**Title:** Permit #24-525: 26275 Smithtown Road Driveway and Utility Installation

**Prepared by:** Name: Veronica Sannes, Permitting Technician  
Phone: (952) 641-4580  
vsannes@minnehahacreek.org

Approval of MCWD permit 24-525 in accordance with the submitted plans and with the following conditions:

**26275 SMITHTOWN RD LOT SPLIT**  
SHOREWOOD, MINNESOTA  
**SITE & UTILITY PLAN**  
FOR  
**TONY AND AMY DENMAN**  
26275 SMITHTOWN RD

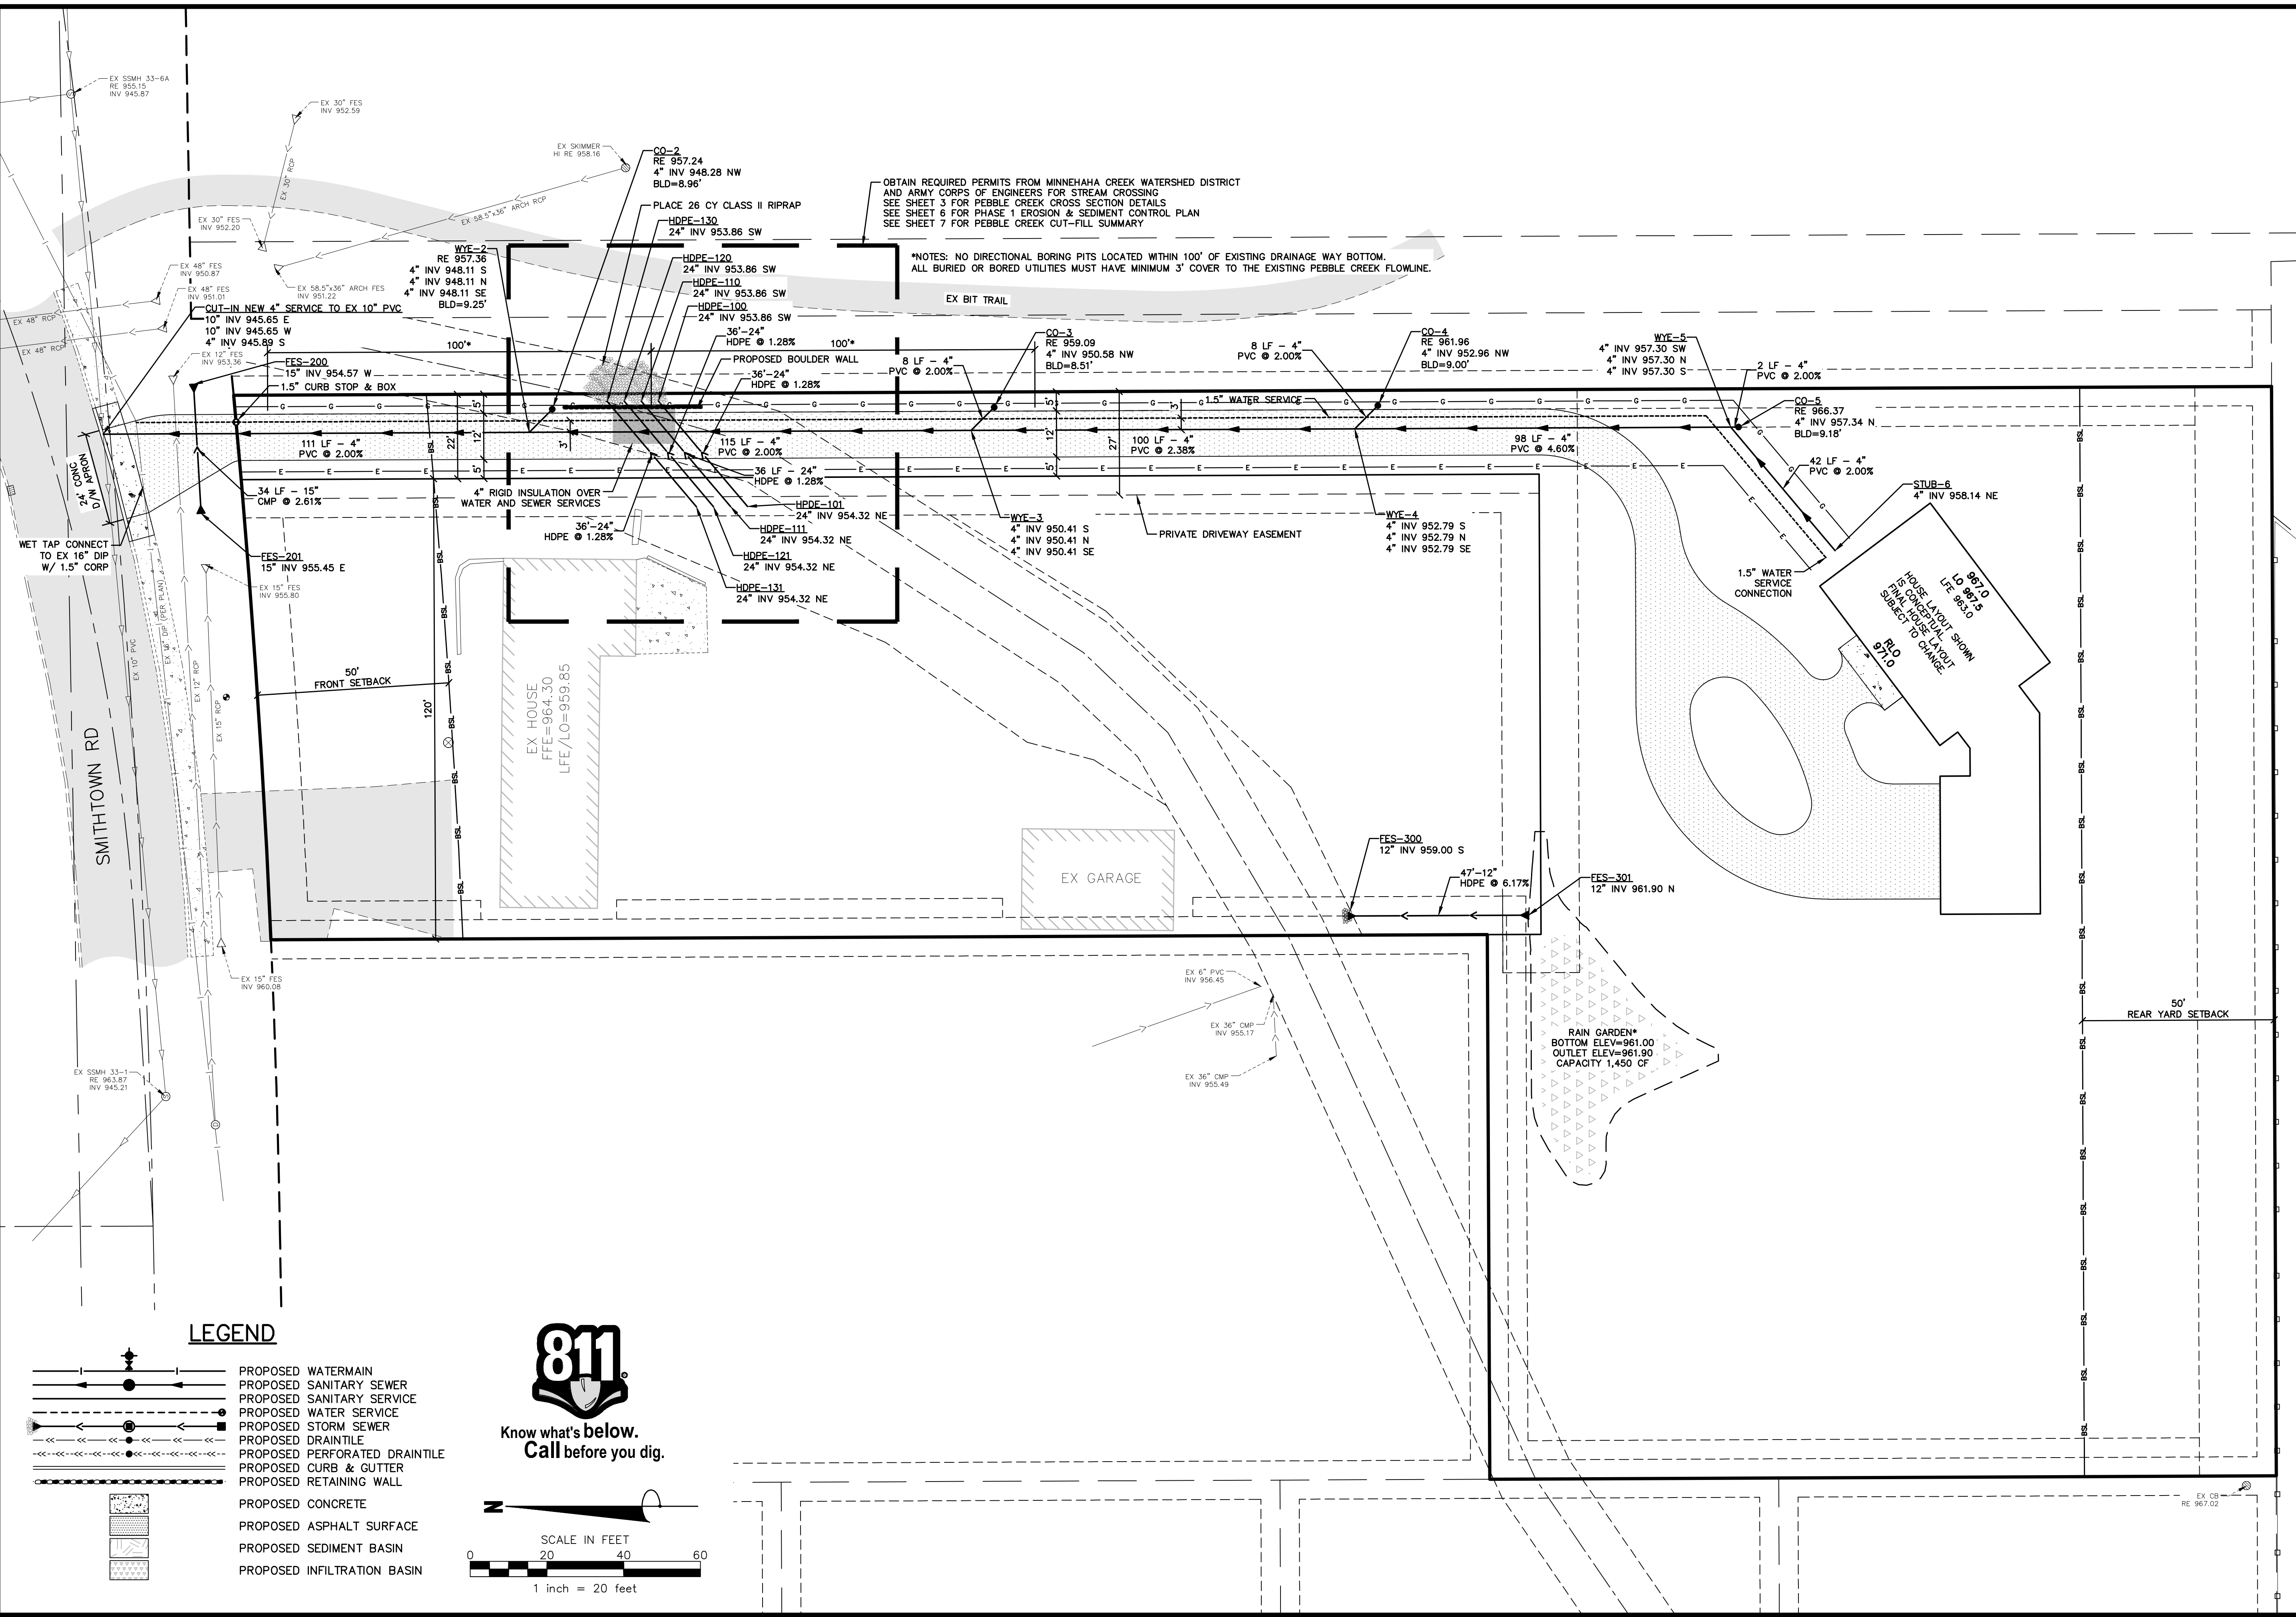
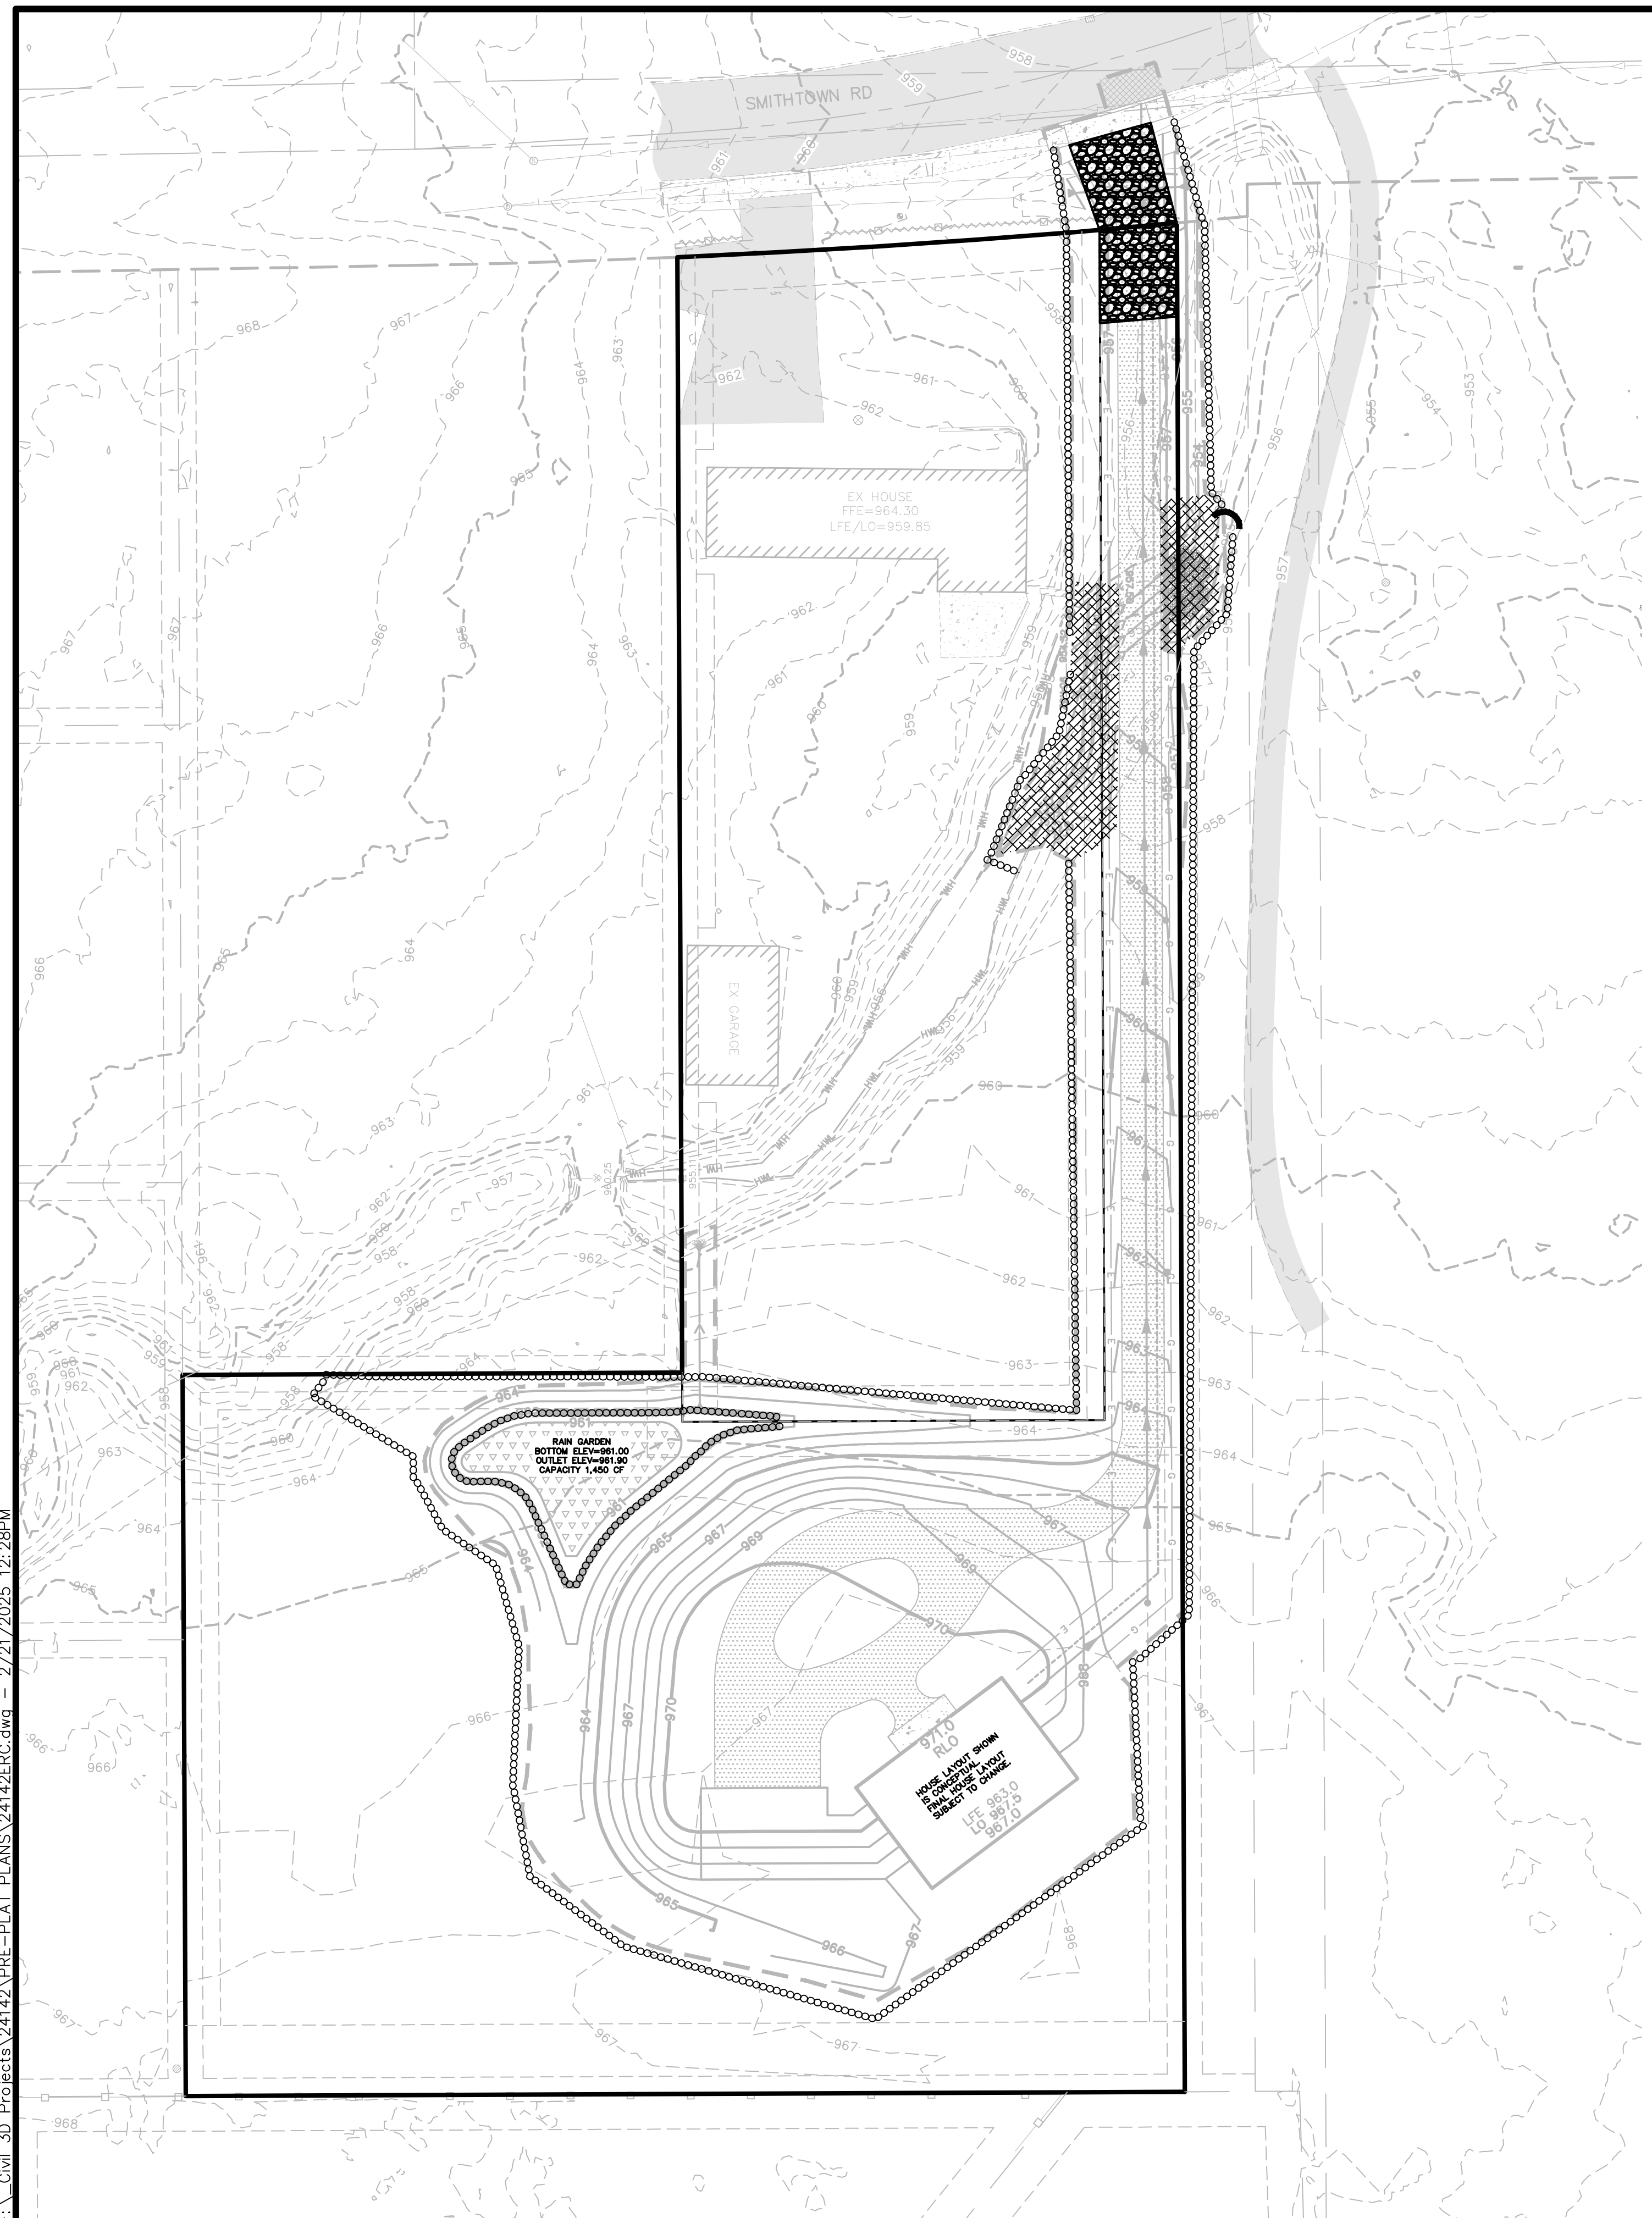
Sections 3(g)1 & 2 require that subsurface crossings provide a minimum clearance of three feet below the bed of a waterbody and a setback of at least 100 feet from the waterbody bank for pilot, entrance, and exit holes associated with horizontal directional drilling. If the 100-foot setback cannot be feasibly provided, the setback may be reduced on the basis of an erosion control plan and other appropriate measures that will preserve streambank integrity and prevent sediment movement. The Applicant proposes to install water, sanitary sewer, phone, cable, gas, and electric lines beneath Pebble Creek. The water and sanitary sewer lines are proposed for immediate construction and will have three feet of clearance beneath the creek. The other utilities will be contracted at the time of the home construction. The plans note that the crossings must have a minimum clearance of three feet below Pebble Creek and that bore holes must be set back at least 100 feet from the waterbody bank. The resubmission of plans with updated utility plans is recommended as a condition of the permit.
